**CITY OF WINTER PARK
PLANNING AND ZONING BOARD**

**Staff Report
April 7, 2015**

REQUEST OF PHILIP KEAN FOR: CONDITIONAL USE APPROVAL UNDER THE CLUSTER HOUSING PROVISIONS OF THE R-2 ZONING DISTRICT TO ALLOW THE CONSTRUCTION OF THREE, TWO-STORY TOWNHOUSE UNITS ON THE PROPERTIES AT 1047 AND 1049 NORTH KENTUCKY AVENUE, ZONED R-2.

REQUEST OF FIFTH THIRD BANK TO: AMEND THE "COMPREHENSIVE PLAN" FUTURE LAND USE MAP SO AS CHANGE FROM SINGLE FAMILY RESIDENTIAL TO A PARKING LOT FUTURE LAND USE DESIGNATION ON THE PROPERTY AT 453 NORTH LAKEMONT AVENUE.

PROPOSED SITE PLAN

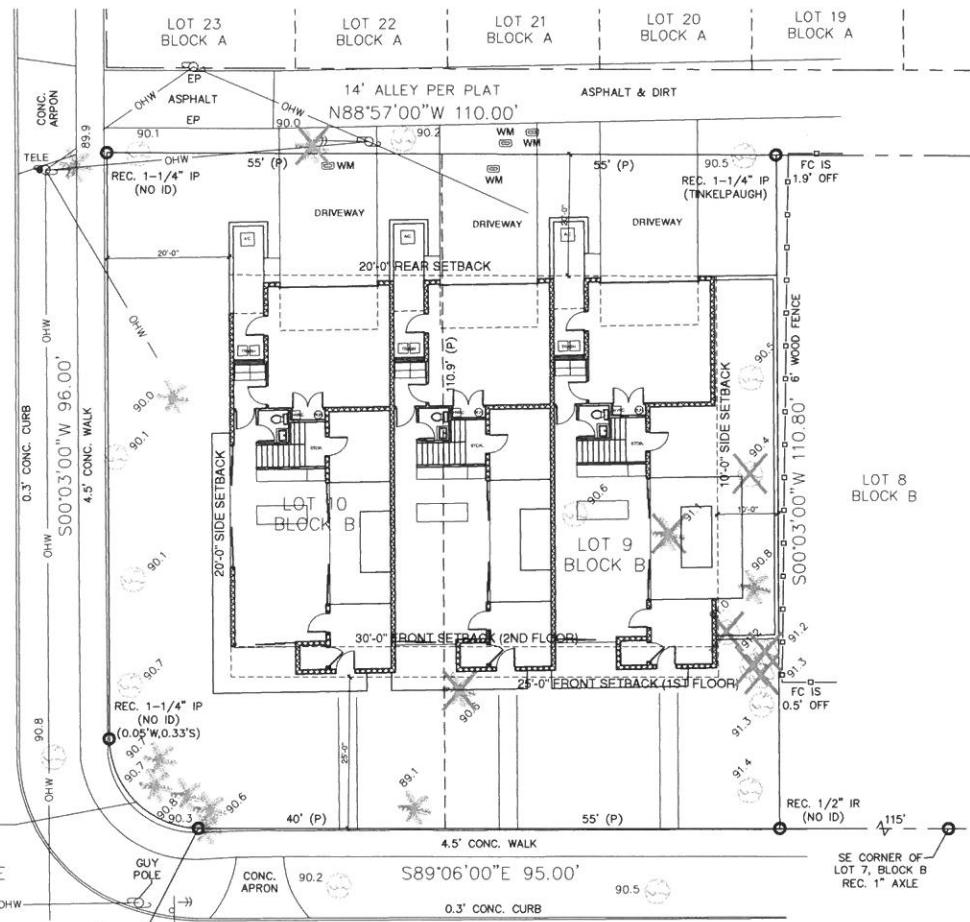
There is a platted city alleyway between these properties that front on N. Kentucky Avenue and the properties that front on Fairbanks Avenue. It runs from Ward Avenue to Denning Drive. The site plan layout utilizes the city alleyway for access providing rear entry driveways from the alleyway into two car garages for each unit. This works to hide the cars from view and present a more attractive building image on the two streets. The two car garages are sized at 20 x 20.6 feet. Technically the parking requirement is 2.5 spaces per unit, so the rear driveways would also count toward meeting that parking requirement, as visitors could park in those driveways.

Storm Water Retention: The project will need to provide on-site storm water retention. At this preliminary stage, that plan has not been engineered but there is ample site area/yard, especially with the corner building setbacks to accomplish the required retention.

Traffic Engineering: The alley needs to be improved and widened for the length of this project.

Electric Utility: There are power poles in the alley that will need to be removed and electric service to be put underground. An easement for a transformer location will need to be provided.

- 1. That the alleyway be paved and improved for the full width of the alley within the confines of this project.**
- 2. That the project replant seven new oak trees, evenly spaces along the N. Kentucky and Ward Avenue frontages.**
- 3. That the project remove the power poles in the alley area and underground electric and other utilities and provide an easement for an electric transformer to serve these three homes.**

Sheet Title
STREET SIGNS AND OUTDOOR LIGHTING

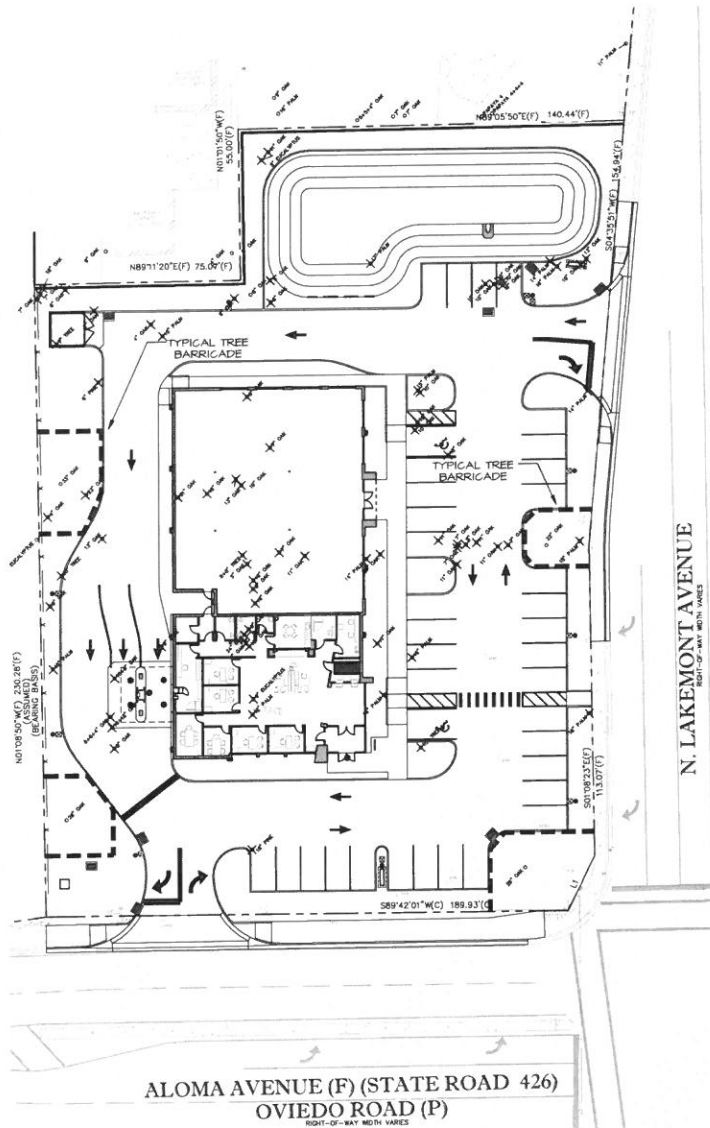
Building Dept.: The plan exceeds the one foot candle maximum at the western property line due to the State mandated lighting requirements for the ATM to be located in the drive-in lane. While the City understands the convenience for user of the ATM; there is no variance to that lighting standard and the ATM may need to be wall mounted on the bank façade unless compliance with the lighting code is achieved.

Sheet Title
LANDSCAPE PLAN

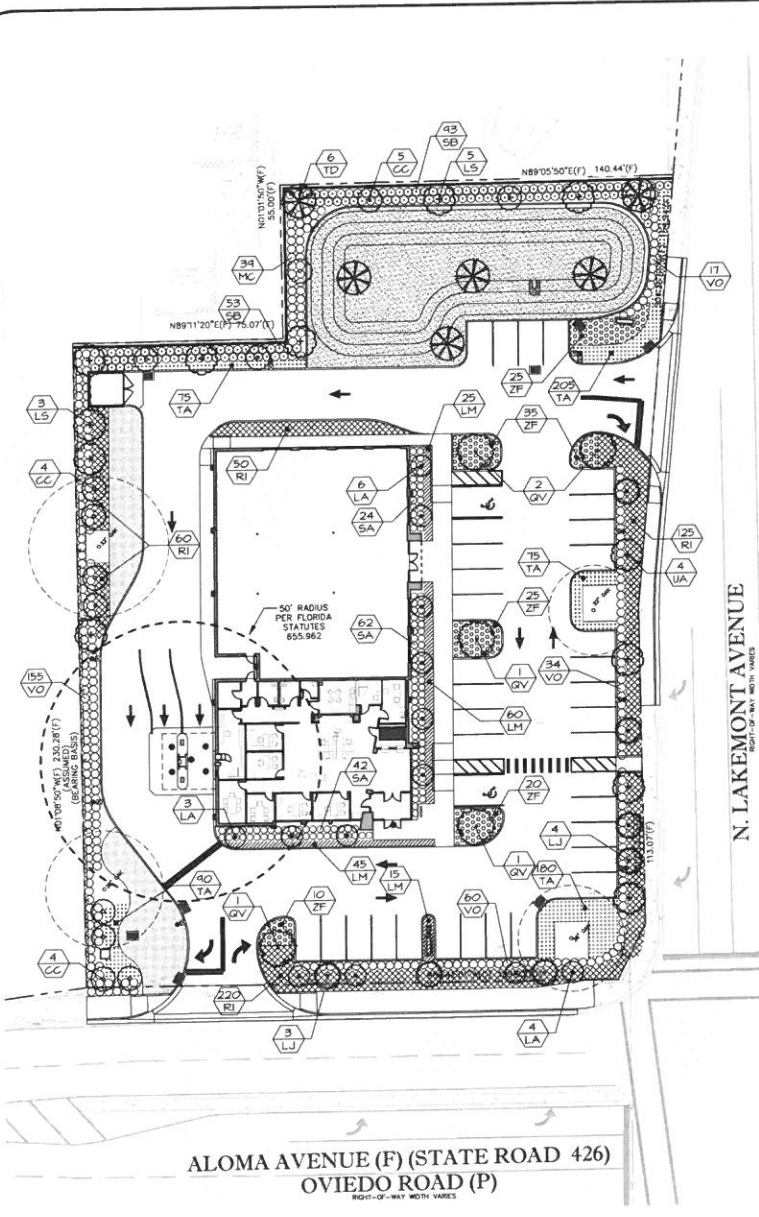
1. Landscape Plan – a more detailed landscape plan for the project is attached. It is not a "permit ready" landscape plan as it does not specify the height, type, quantity, spacing of landscape materials. But we do now see the location of 40+ new shade trees to be planted for the project.

- 1. That the final landscape site plan be modified to include more substantial landscape screening and trees for the parking garage in the setback areas including new trees and other landscape materials determined by the City Staff and that only oak trees be allowed within the interior of the project wherever it is determined new tree plantings will occur where space is adequate for oak trees.**
